**PARK 183 BUILDINGS 6 & 7**

**SP-2021-0072C**

*Tunde Daramola*

# **VARIANCE REQUEST**

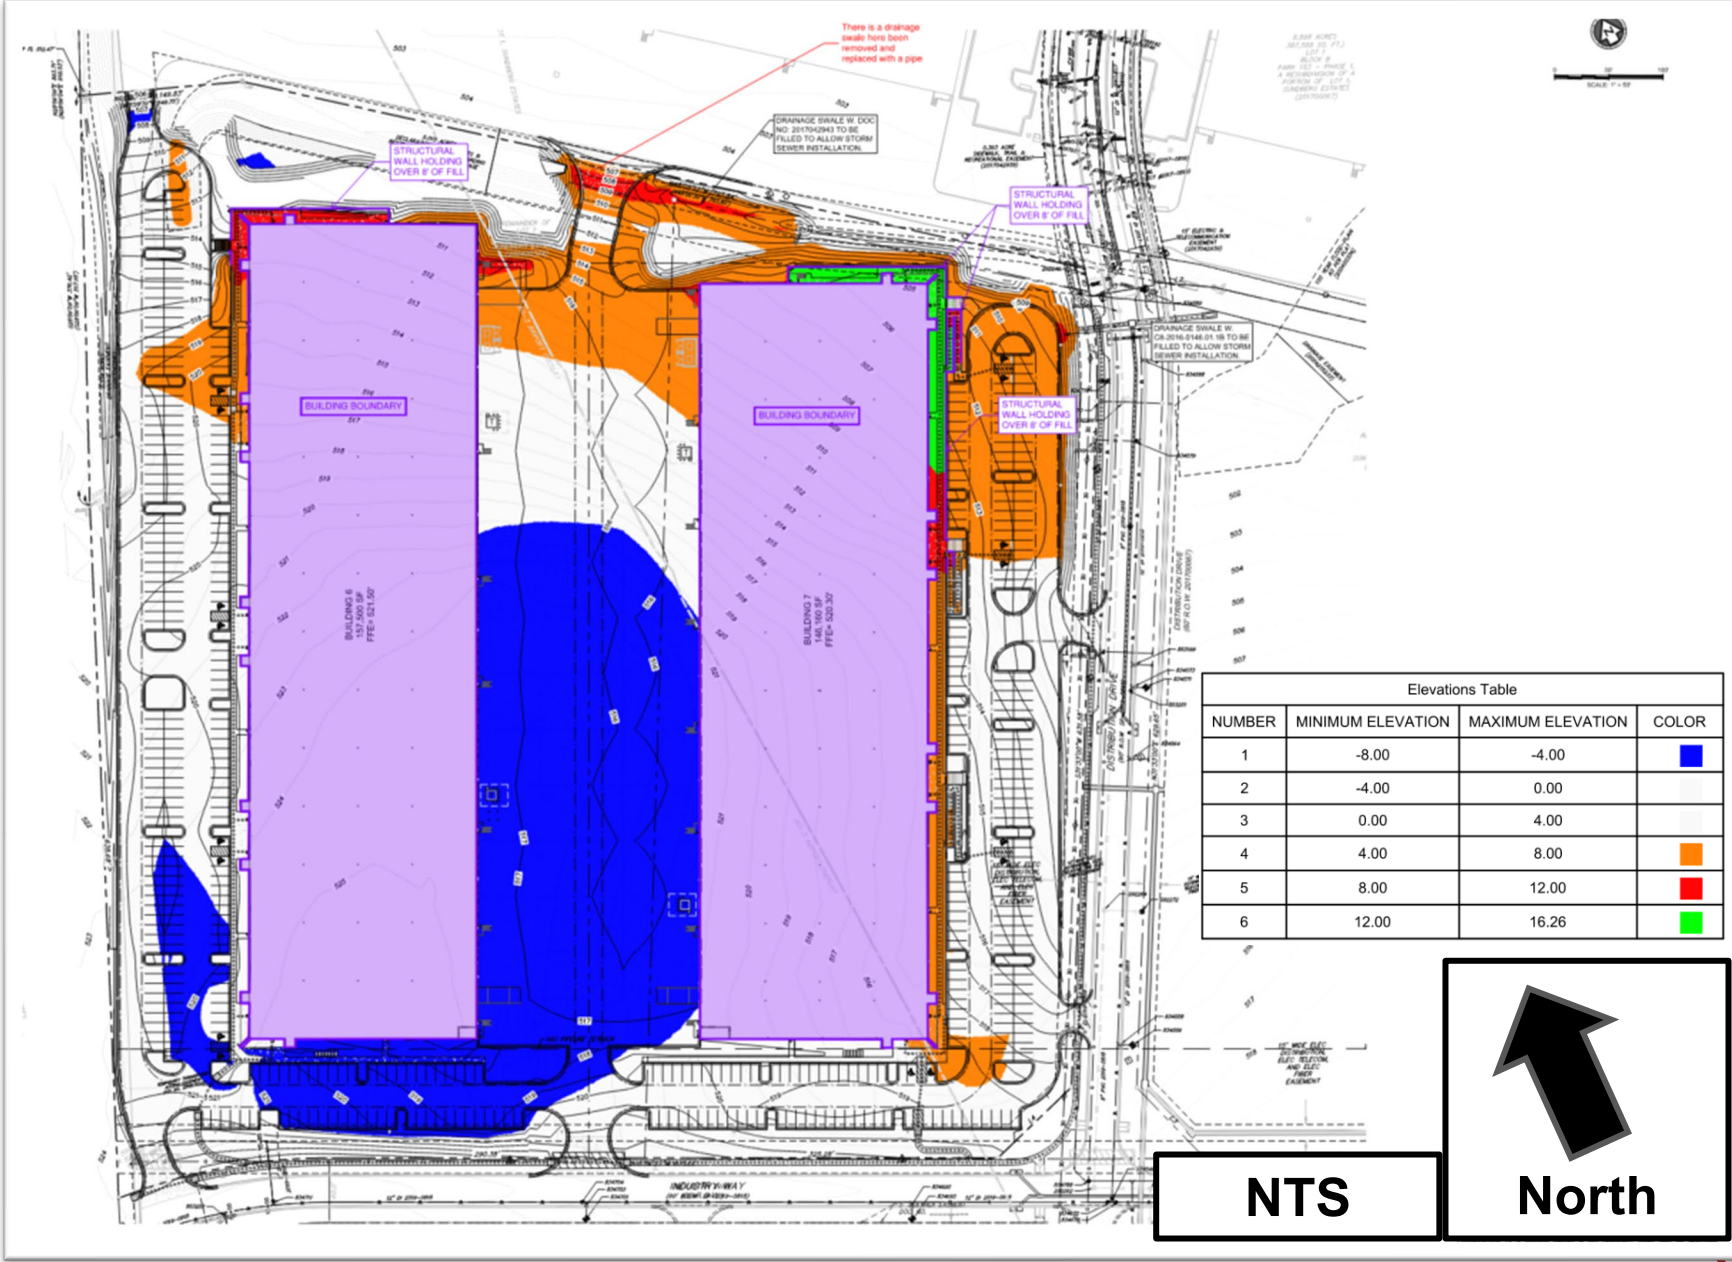
- **To allow fill in excess of four feet and up to 17 feet within the Desired Development Zone. (LDC 25-8-342)**

**Staff has determined that the required findings of fact have been met and recommends the following condition:**

- **Provide structural containment of fill with retaining walls.**

# RETAINING STRUCTURES

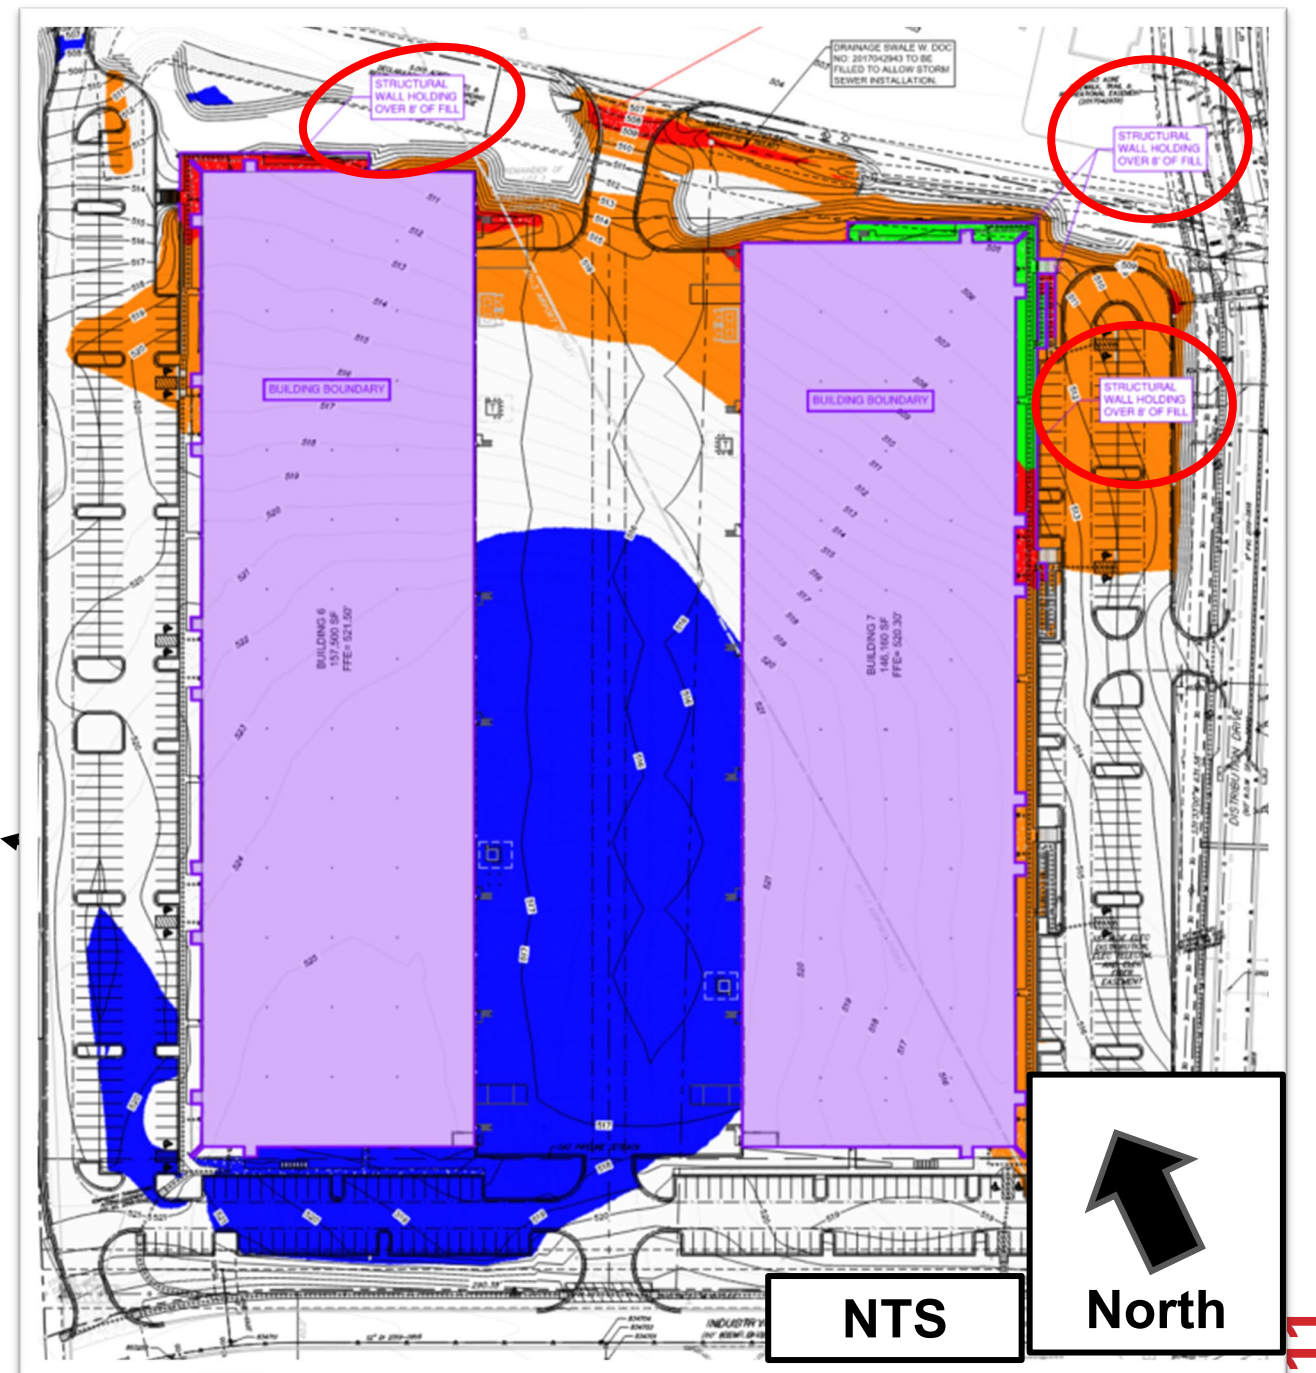
- Retaining walls to structurally contain fill and minimize the amount of grading
- Resist lateral pressure of the soil.
- Prevent movement of soil downward.
- Enhancing stability.
